Accounting for Compensable and Un-compensable ISI Considering Adopted SNDR Measurement Requirements (ref: Comment #93)

IEEE 802.3bs 200 Gb/s and 400 Gb/s Ethernet Task Force

120D.3.1.3 Linear fit to the measured waveform

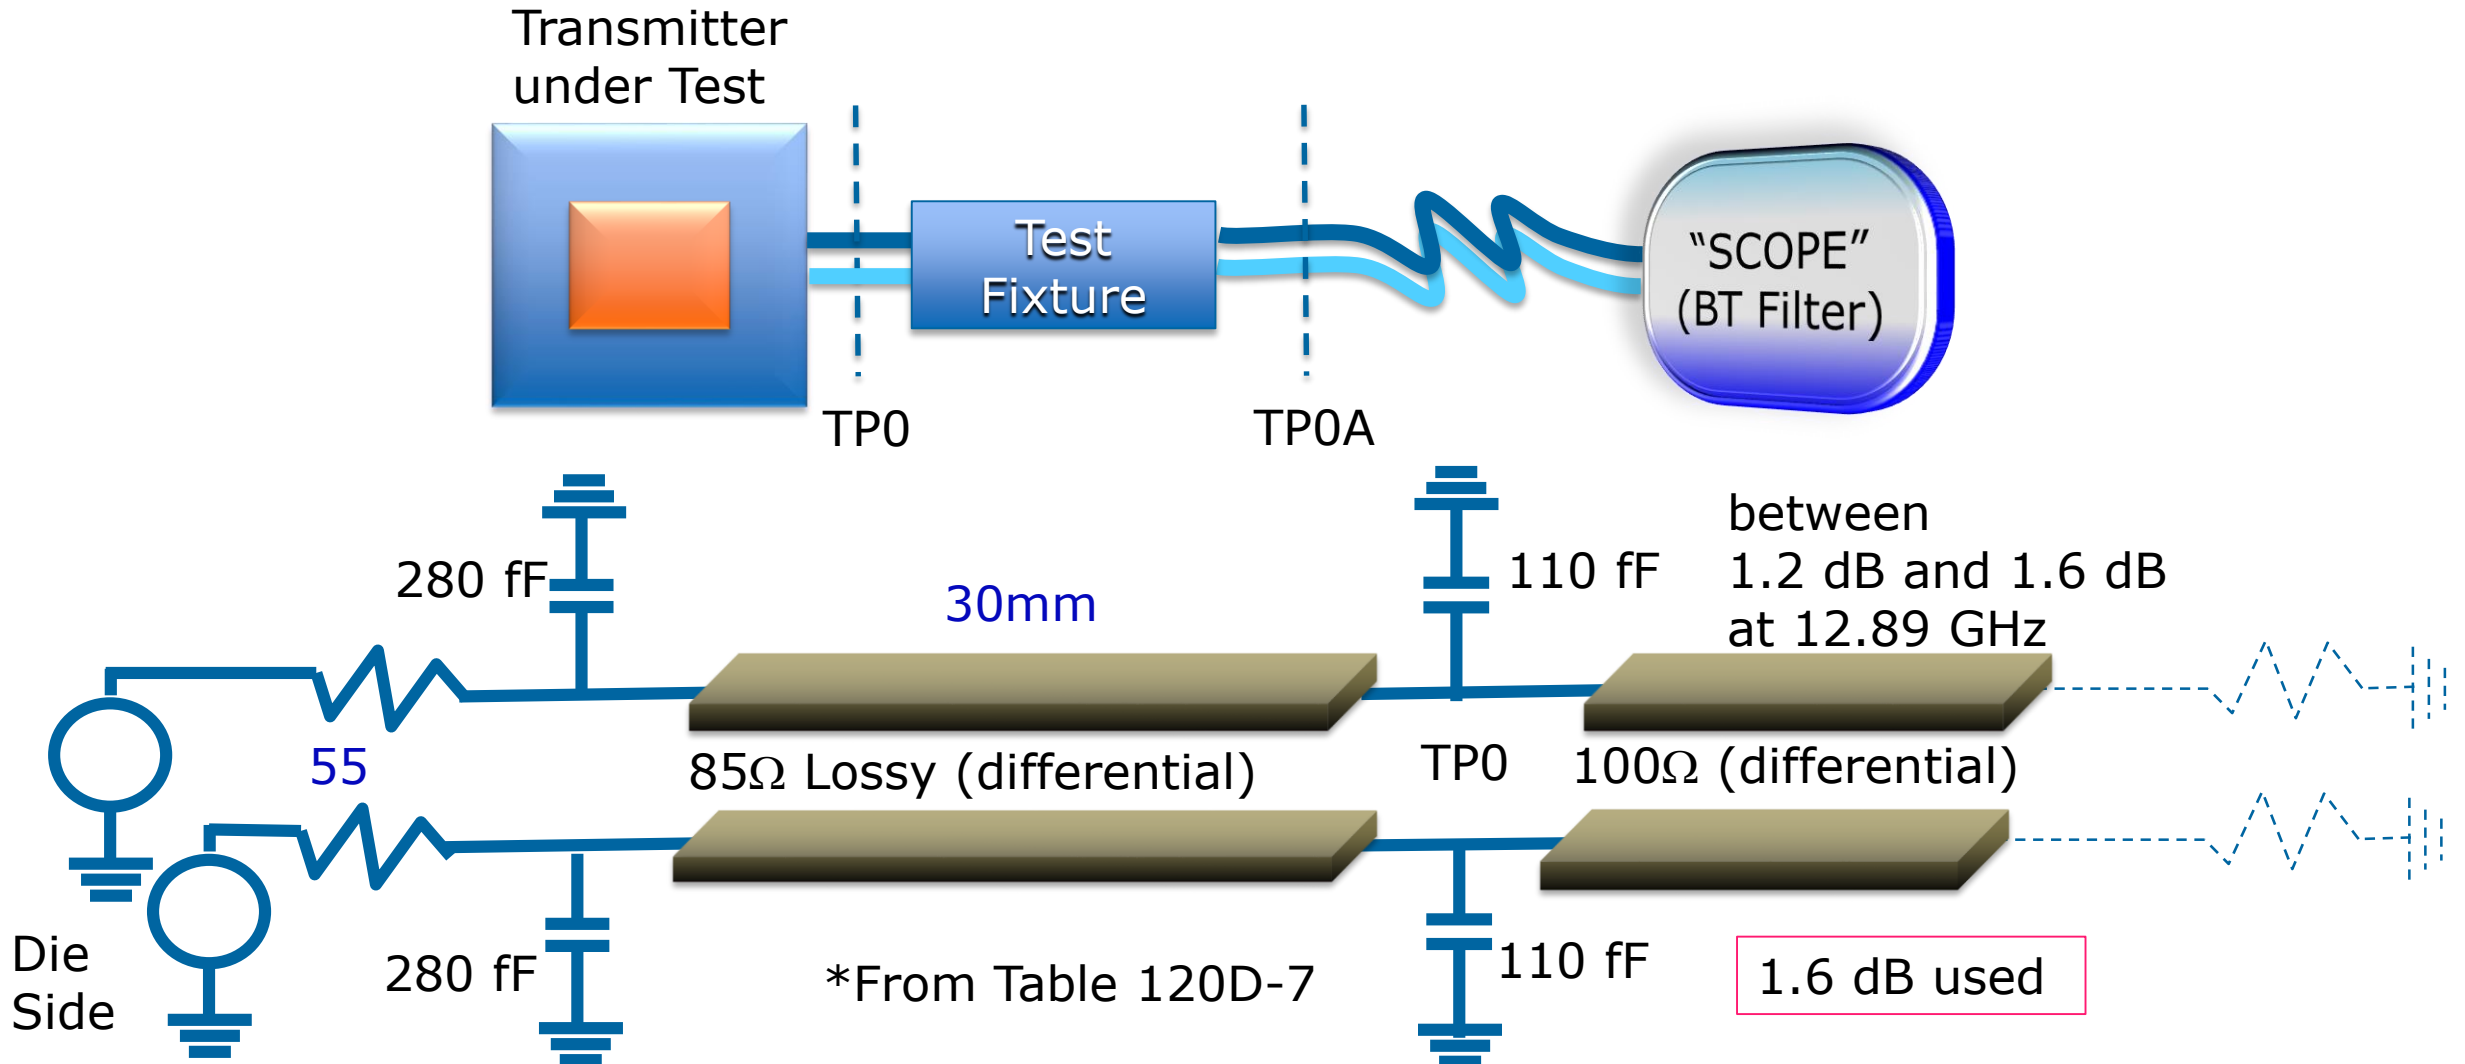
– This c) The value of D_p is 2, and the value of N_p is 200.

– The purpose of this comment is to limit the package/device ISI

Explore packages which could fail: Zp=40mm [1]

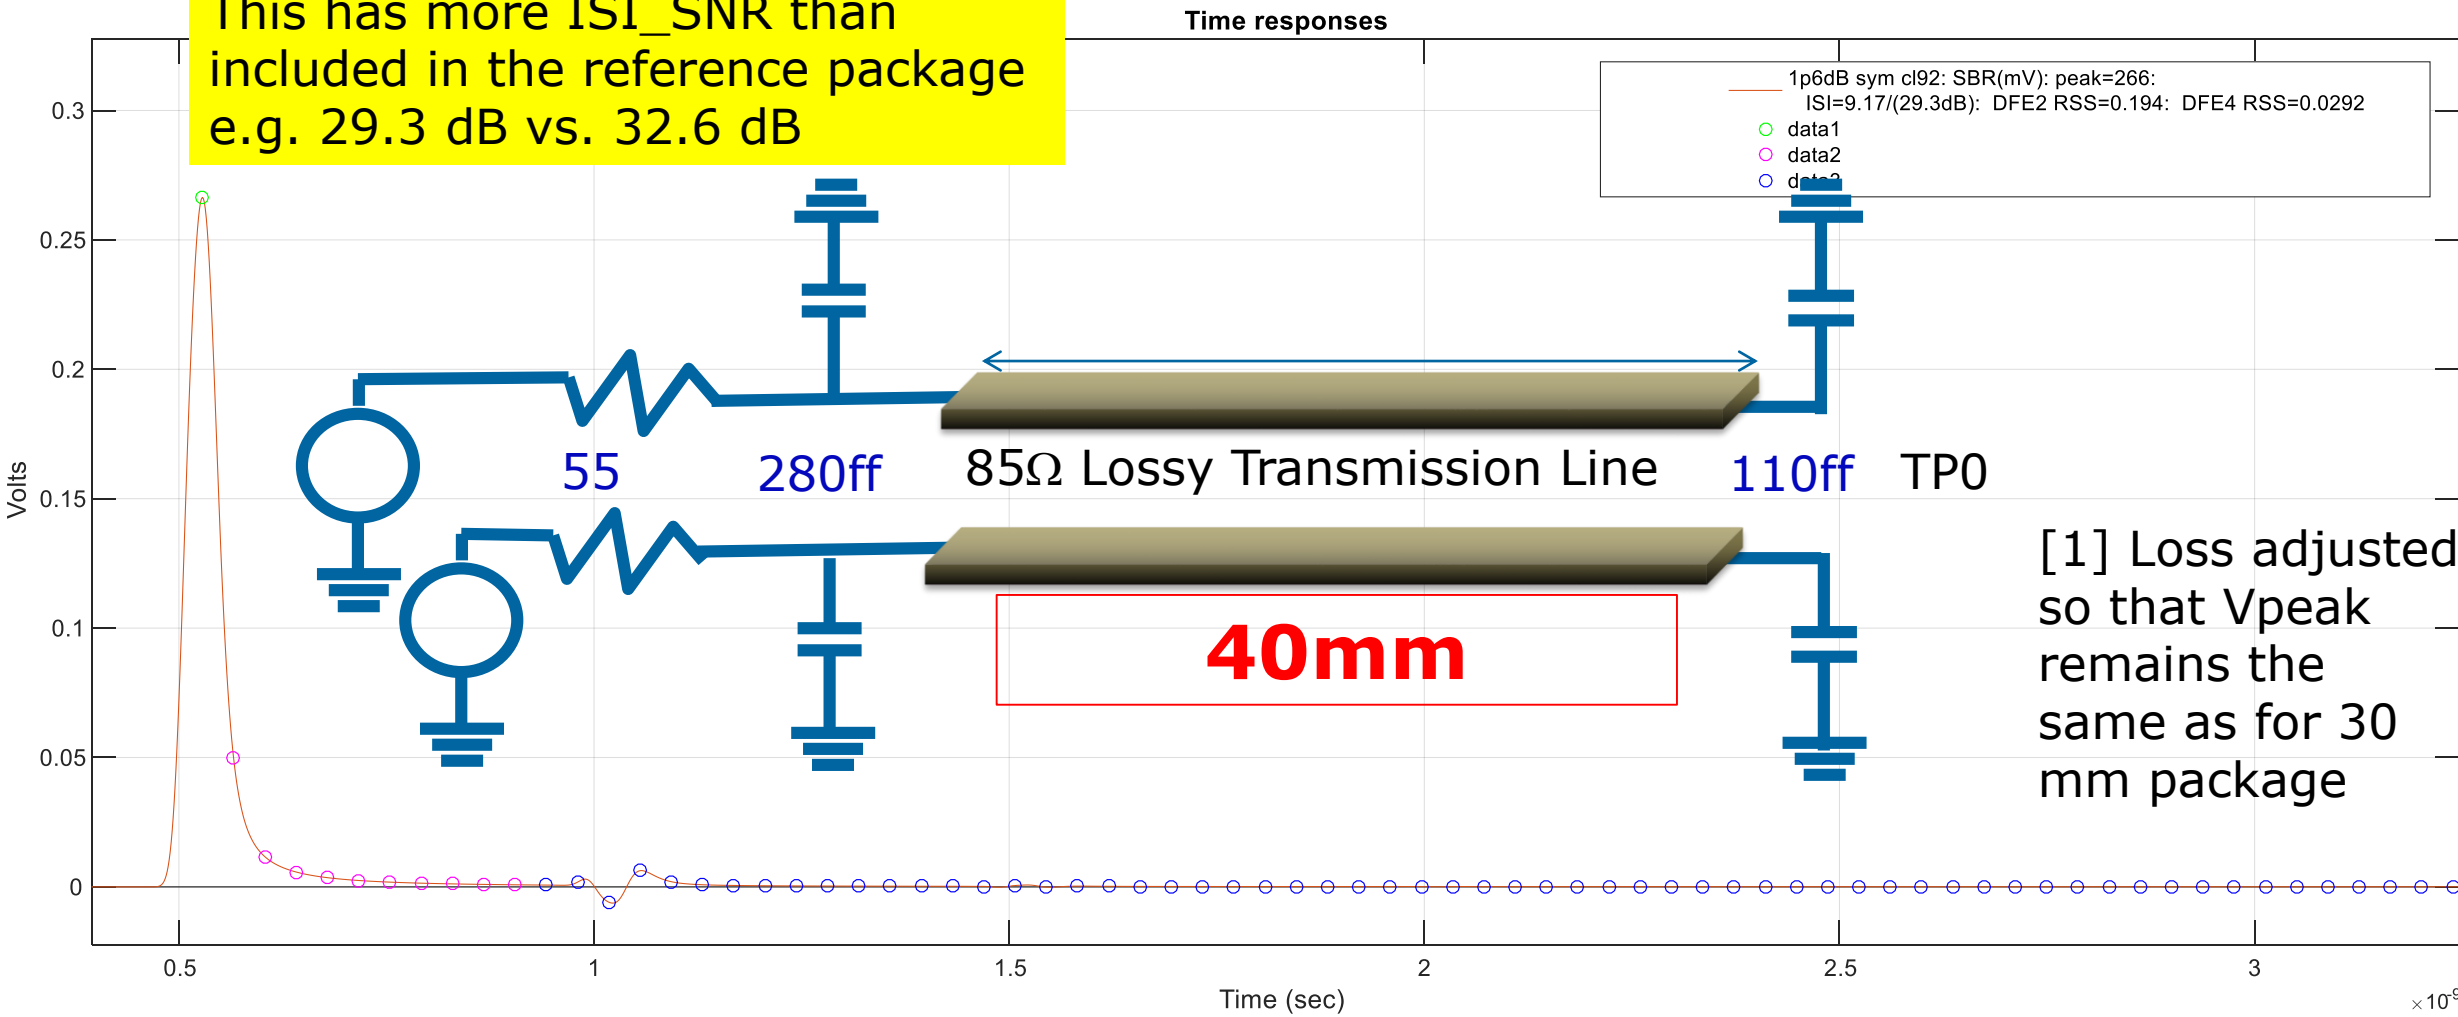
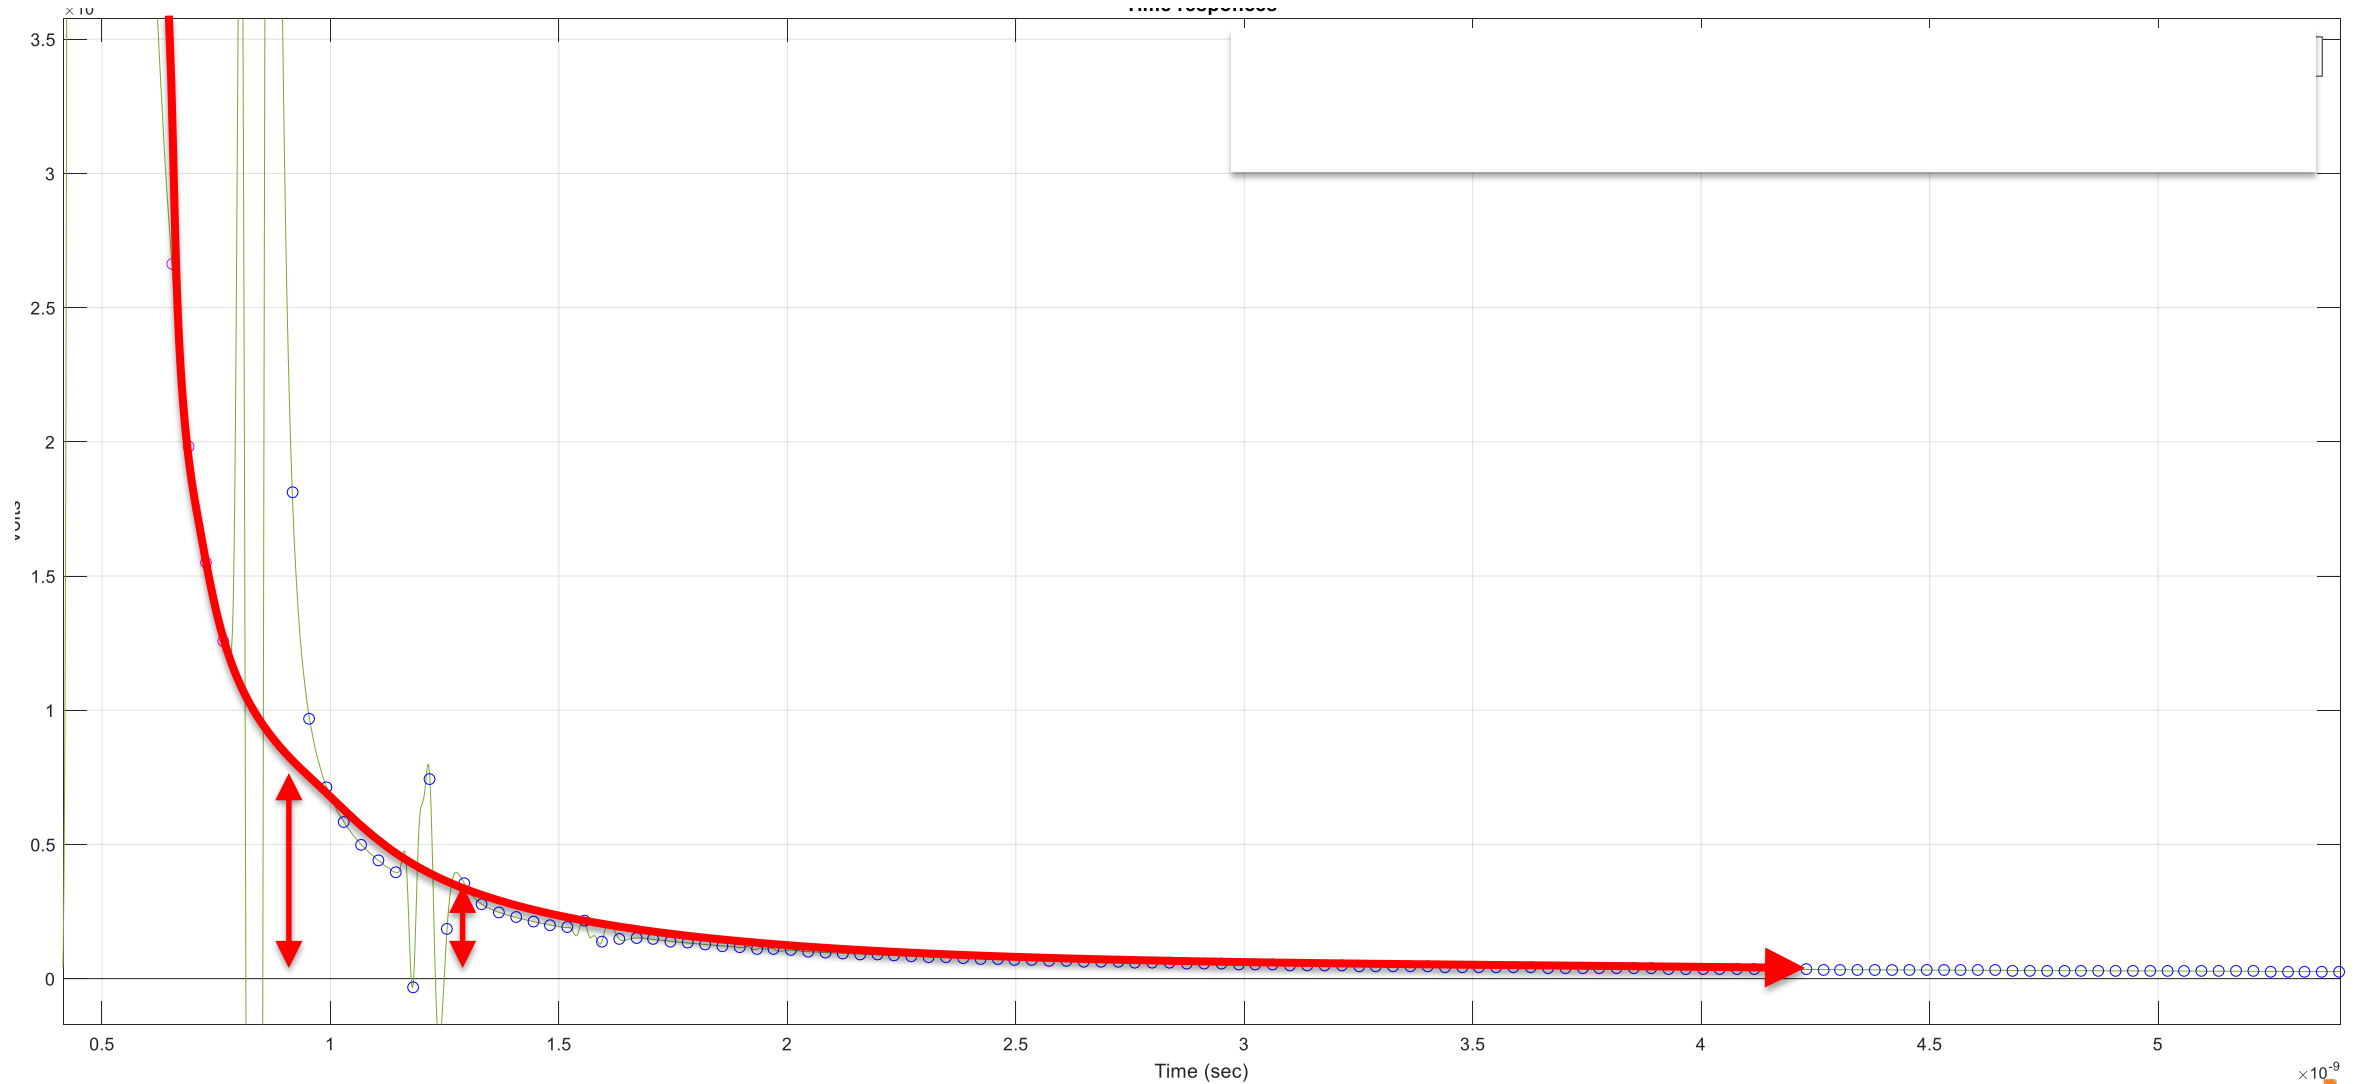
This has more ISI_SNR than included in the reference package e.g. 29.3 dB vs. 32.6 dB

Linear equalization will remove the dispersion effect yielding a more true view of reflections

- ▶ Apply CTLE. Optimize for maximum ISI_{SNR}
- ▶ Add a table entry, ISI_{SNR} (min) of 32.3 dB
 - Some margin added for fixture variation
- ▶ Two options
 1. Perform for the preset Tx equalization setting (no eq.)
 2. Perform for all Tx equalization settings

Recommend option 1
